45 HONEYSUCKLE DRIVE, NEWCASTLE - MIXED USE DEVELOPMENT (SSD-9827-MOD1)

I refer to the Department's electronic notification of 20 August 2020 advising the applicant has submitted a Section 4.55 (1A) application seeking consent to modify the development consent and inviting City of Newcastle ('CN') to provide advice.

Extract from Figure 6.01-20: Network Access Map

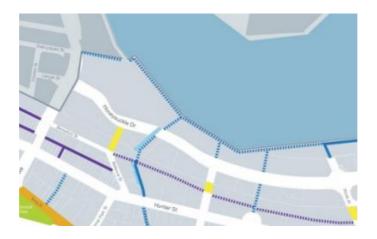
The following extract from Figure 6.01- 20 shows the primary links to the eastern end of subject site and Cottage Creek connection.

The Honeysuckle Drive frontage of the site is approximately 124m long (excluding the provided accessway at the eastern end of site), so therefore additional through site pedestrian permeability would generally be required under the provisions of the DCP in addition to the primary pedestrian links identified above.
